JACK'S PLACE AT MAGNOLIA GROVE SUBDIVISION

Engineering Comments: REVISED FINAL PLAT COMMENTS (should be addressed prior to submitting the FINAL PLAT for review and/or signature by the City Engineer):

APPLICATION NUMBER 5 DATE March 15, 2018

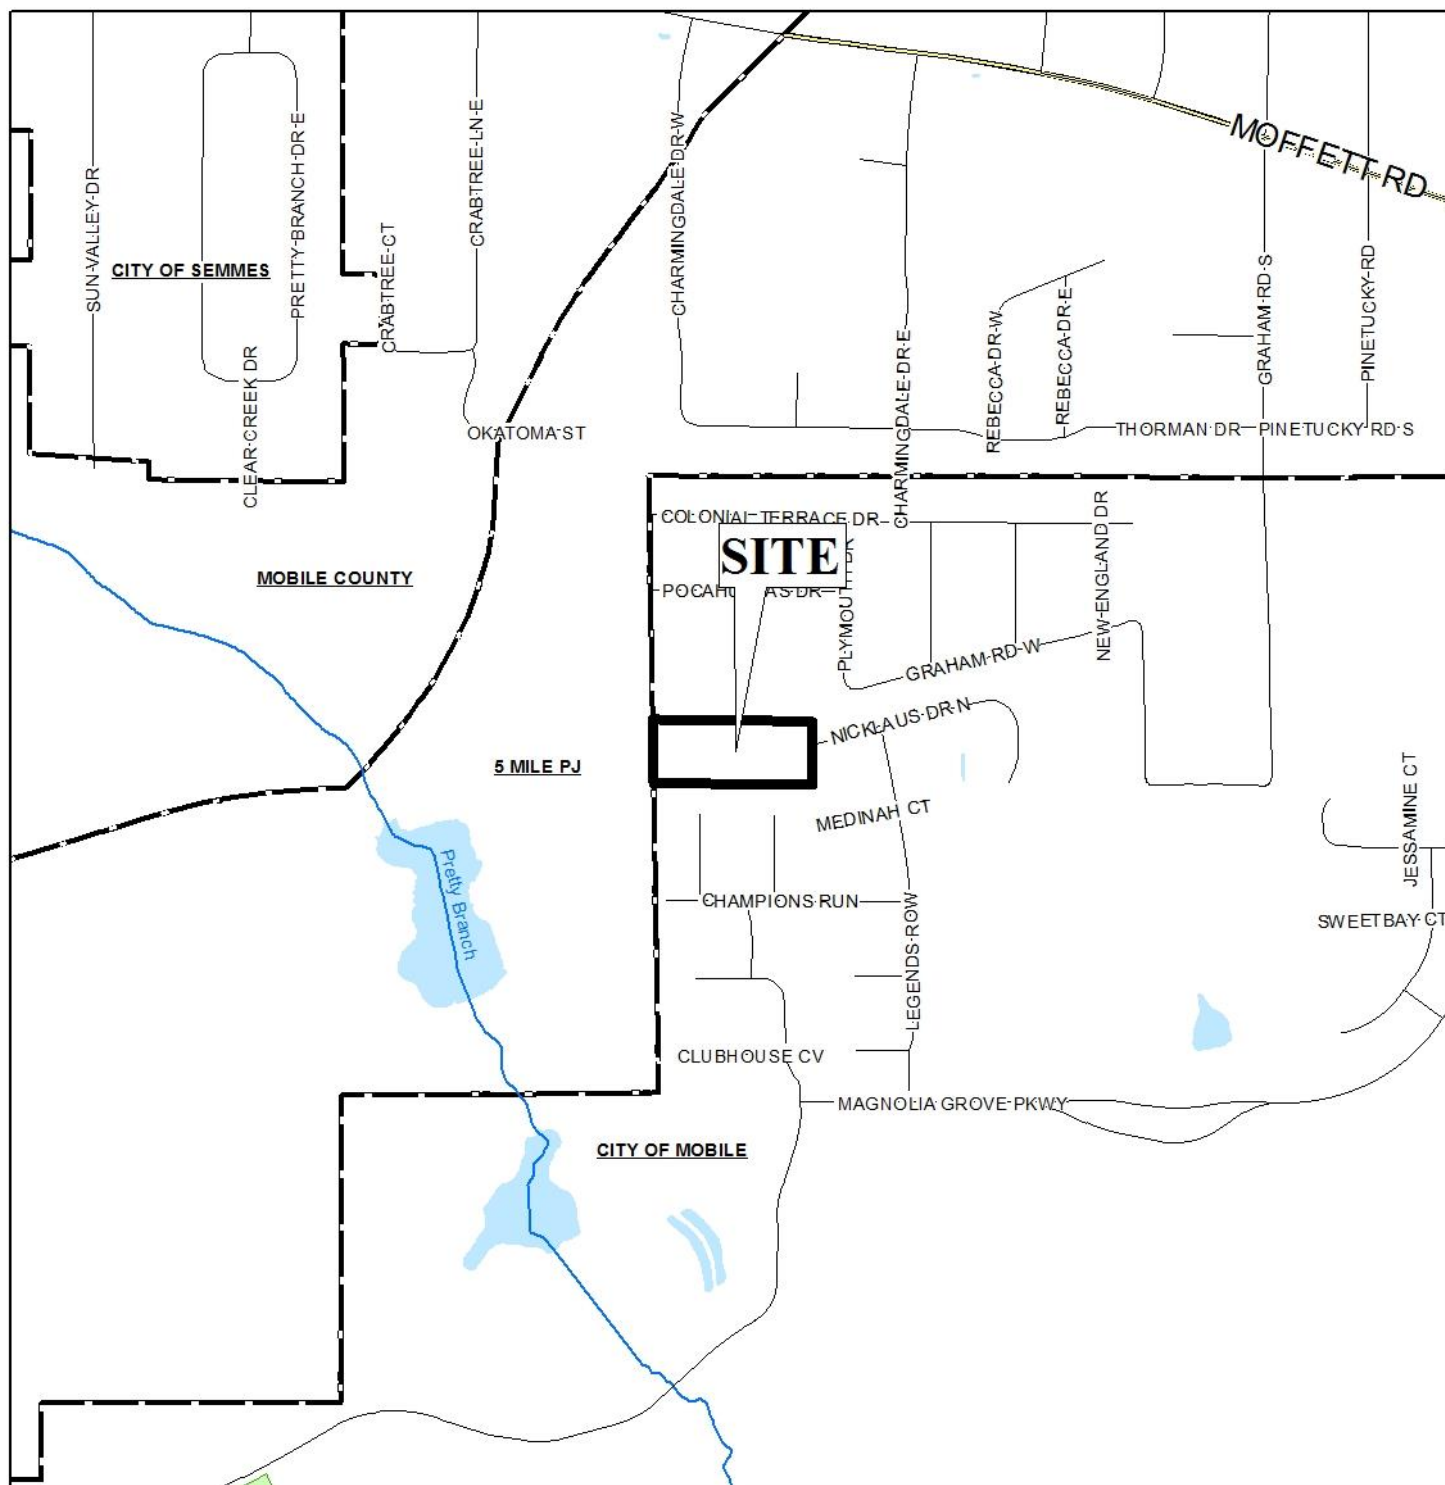
Each of the proposed lots will have frontage along the proposed extension to Nicklaus Drive North, a minor closed-end street requiring a 50' right-of-way. Sufficient right-of-way is illustrated on the preliminary plat, as is an adequate turnaround right-of-way diameter of 120' at

the terminus of Nicklaus Drive North, per Section V.D.14. of the Subdivision Regulations. As such, no additional dedication should be required.

With regards to access management, a note should be placed on the Final Plat stating that the lots are each limited to one (1) curb cut to Nicklaus Drive North, with any changes in their sizes, locations, or designs to be approved by Traffic Engineering and conform to AASHTO standards.

Common area is proposed to abut Lot 17. It, too, should be limited to one (1) curb cut to Nicklaus Drive North, with any changes in its size, location, or design to be approved by Traffic Engineering and conform to AASHTO standards. A note should also be required on the Final Plat stating that the maintenance of all common areas shall be the responsibility of the property owners.

Each of the proposed lots will meet the minimum size requirements for lots served by public water and sanitary sewer systems, and are appropriately labeled in square feet and acres on the preliminary plat. The size of the proposed common area is also appropriately labeled in square feet and acres. This information should be retained on the Final Plat, if approved; or, provision of a table on the Final Plat providing the same information may suffice.

The 25' minimum building setback line is illustrated along each of the proposed lots, and should be retained on the Final Plat, if approved. Additional side and rear yard setback lines are illustrated on the preliminary plat and, while their illustration is not a requirement of the Subdivision Regulations, they do meet the minimum yard requirements of the Zoning Ordinances for lots within the applicable zoning district.

Revision of the plat to illustrate the 25' minimum building setback line along the frontage of the proposed common area should be required, if approved.

Finally, a 5' drainage easement is illustrated along the rear portions of proposed Lots 9-17, and a 10' utility easement is illustrated along the frontage of all proposed lots and common area. As such, a note should be placed on the Final Plat stating no structures shall be constructed in any easement.

- 1) all new road construction must comply with Engineering and Traffic Engineering requirements;

- 2) placement of a note on the Final Plat stating that each lot is limited to one (1) curb cut to Nicklaus Drive North, with any changes in their sizes, locations, or designs to be approved by Traffic Engineering and conform to AASHTO standards;

- 3) placement of a note on the Final Plat stating the common area is limited to one (1) curb cut to Nicklaus Drive North, with any changes in its size, location, or design to be approved by Traffic Engineering and conform to AASHTO standards;

- 4) placement of a note on the Final Plat stating that the maintenance of all common areas is the responsibility of the property owners;
- 5) retention of the lot and common area sizes in both square feet and acres on the Final Plat, or provision of a table on the Final Plat with the same information;

- 6) retention of the 25' minimum building setback line along the frontage of each lot;
- 7) revision of the plat to illustrate the 25' minimum building setback line along the frontage of the common area;

- 8) placement of a note on the Final Plat stating no structures shall be constructed in any easement;
- 9) compliance with Engineering comments: *(REVISED FINAL PLAT COMMENTS (should be addressed prior to submitting the FINAL PLAT for review and/or signature by the City Engineer): A. Provide all of the required information on the SUBDIVISION PLAT (i.e. signature blocks, signatures, certification statements, written legal description, required notes, legend, scale, bearings and distances) that is required by the current Alabama State Board of Licensure for Professional Engineers and Land Surveyors. B. Show and label the existing and proposed ROW monumentation of the existing portion of Nicklaus Dr. N. and the proposed continuation C. Label the proposed use of the Common Area (i.e. Open Space, Detention, etc.) D. Revise GENERAL NOTE #7 to read "Maintenance and operation of any detention facilities and common areas shall be the responsibility of the Property Owner(s), and not the responsibility of the City of Mobile." E. Provide a detail of the property corner at the southeast corner of the COMMON AREA. F. Provide the Surveyor's, Owner's (notarized), Planning Commission, and Traffic Engineering signatures. G. Add a note to the plat stating that all easements shall remain in effect until vacated through the proper Vacation process. H. The proposed road shall be constructed in accordance with current Engineering Department policy letters and design criteria. This would allow the potential for future acceptance of the roadway (and dedicated ROW) by the City. I. Provide the as-built certification form, test reports, etc. and as-built plans for the proposed infrastructure prior to providing a copy of the FINAL PLAT to the Engineering Dept. for FINAL PLAT review. J. The street must be submitted for acceptance by the Mobile City Council prior to submitting the Final Plat for City Engineer signature. K. Provide a copy of the FINAL SUBDIVISION PLAT to the Engineering Dept. for review. No signatures are required on this drawing. L. After addressing all of the FINAL SUBDIVISION PLAT review comments by the Engineering Dept. provide the ORIGINAL (with all other signatures) and one (1) copy (signatures not required) of the revised Final Plat to the Engineering Department.);*
